# P802.1ASdm/D2.0 February 1, 2024

# Draft Standard for Local and metropolitan area networks—

# Timing and Synchronization for Time-Sensitive Applications

# Amendment: Hot Standby and Clock Drift Error Reduction

Figure 7-5—Time-aware network example for GM redundancy with one primary GM and one secondary GM, which are separated in two gPTP domains

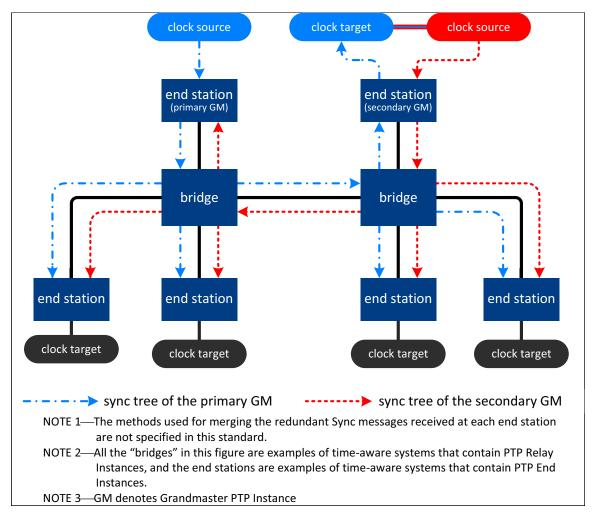
Figure 7-5 shows an example network with two redundant GMs, one as primary GM and the other as secondary GM, where each GM has one of the two redundant synchronization trees originating from it. This example supports hot-standby operating mode. In this mode, the secondary GM has to be synchronized to the primary GM, because it is part of the synchronization tree of the primary GM as shown in the figure.

Figure 7-6 shows another example network, which involves ring topology, using the redundancy features of both Figure 7-4 and Figure 7-5.

For the techniques shown in the examples of Figure 7-4, Figure 7-5, and Figure 7-6, the detection component, correction component, and action component are not fully specified in this standard.

Delete Figure 7-6.

Figure 7-7—Model for PTP Instance and its interfaces to higher-layer applications model

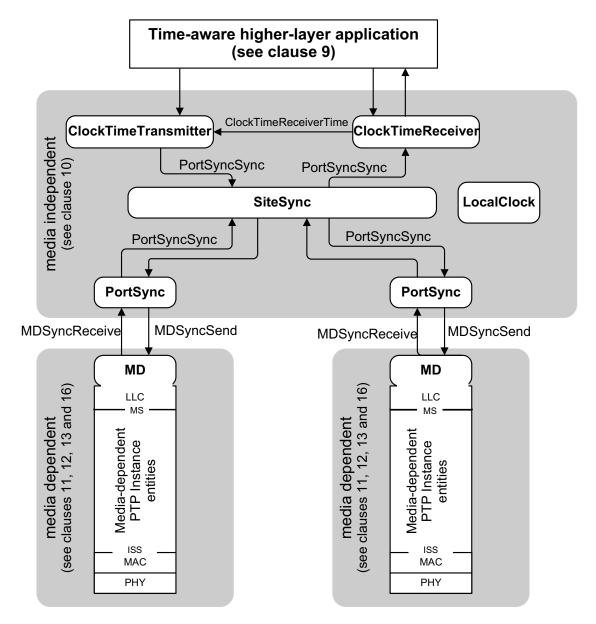
## Change the first paragraph of 7.4 and the caption of Figure 7-8 as follows:

The model of a PTP Instance <u>and its interfaces to higher-layer applications are is</u> shown in Figure 7-7. The <u>interfaces are those specified in Clause 9.</u>

Figure 10-22—GptpCapableReceive state machine

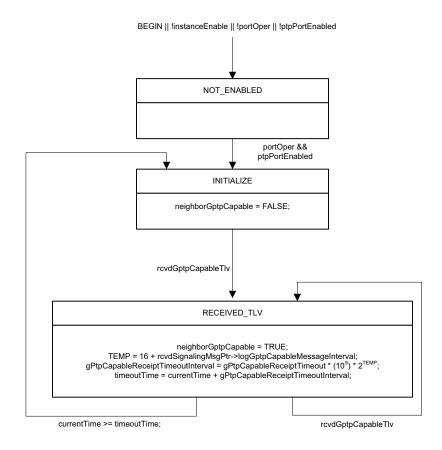
# Replace Figure 10-22 with the following:

Figure 17-4—Common services detail

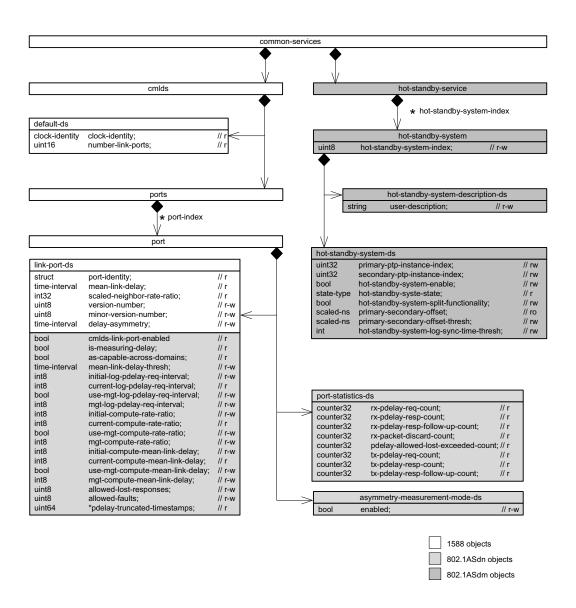
#### Replace Figure with the following:

NOTE 4—This figure differs from the 2020 edition of this standard with Corrigendum 1 applied and as amended by IEEE Std 802.1ASdn in that managed objects needed for the hot standby and Drift Tracking TLV features are added.
